**Review of Previous After-The-Fact Pictures**

*Daniel F. Ardito, PE* has completed this report of pictures of a previous After-The-Fact project I have looked at. This project was a wood frame deck attached to an older mobile home.

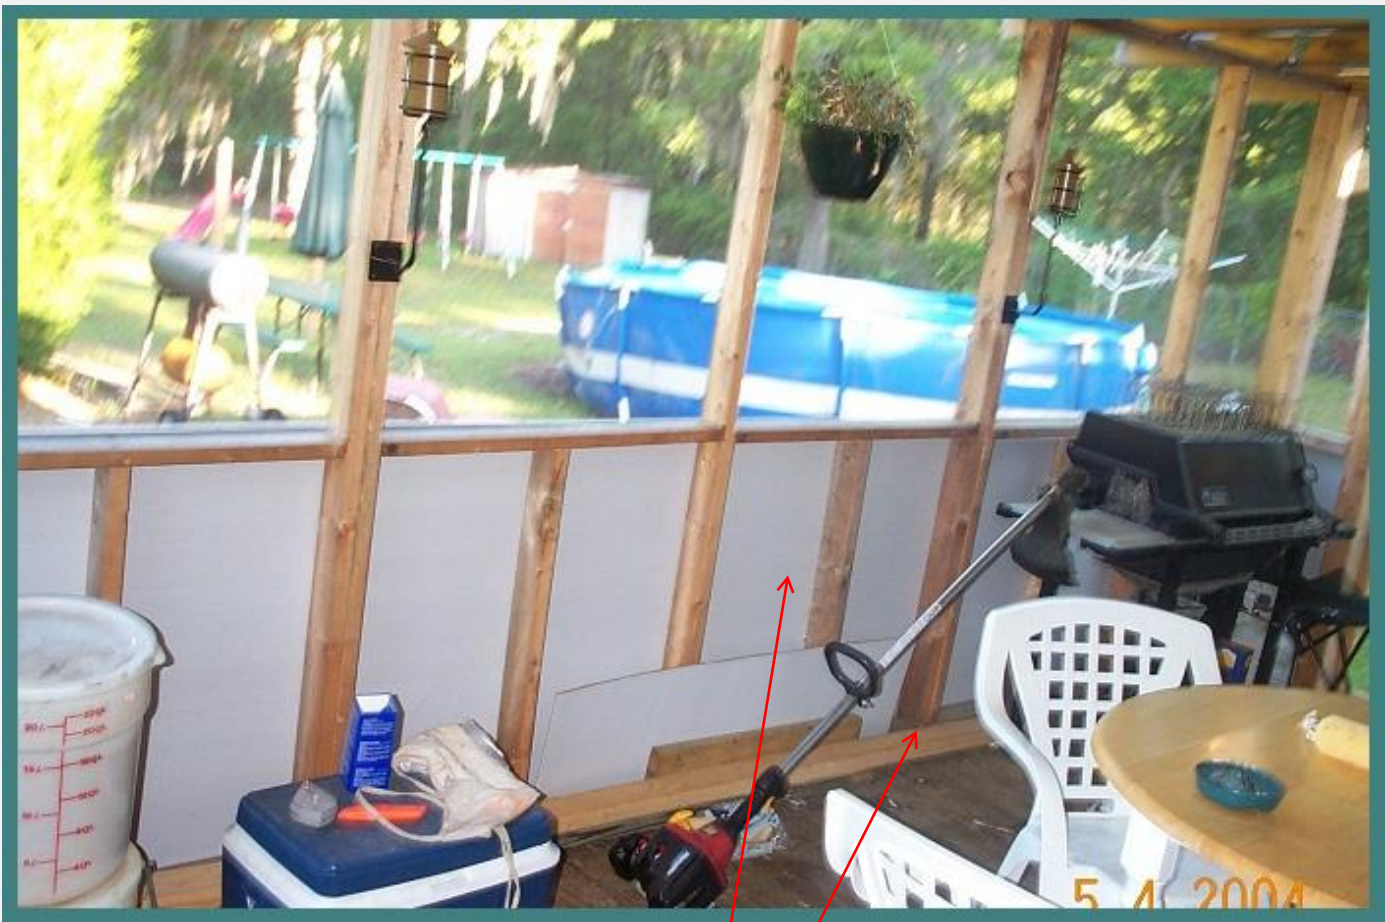
2x4 Rafters are Most Likely Inadequate for the Span

I Would Need to See How the 1x4 Purlins are Attached to Each Rafter.

Flat 2x4 SPF Gr #2 Ledger is Most Likely of Inadequate Strength for the Spacing of Posts.

Inside Framing of the Existing Mobile Home Walls Would Need to be Visible to Evaluate This Connection. My Experience Shows the Existing Framing and Uplift Connectors are Inadequate.

Standard Drywall Makes for a Poor Shear Wall and Will Not Last Long in Damp Weather.

Bottom of Posts Need to Be Connected to the Floor System With Some Sort of Uplift Connectors
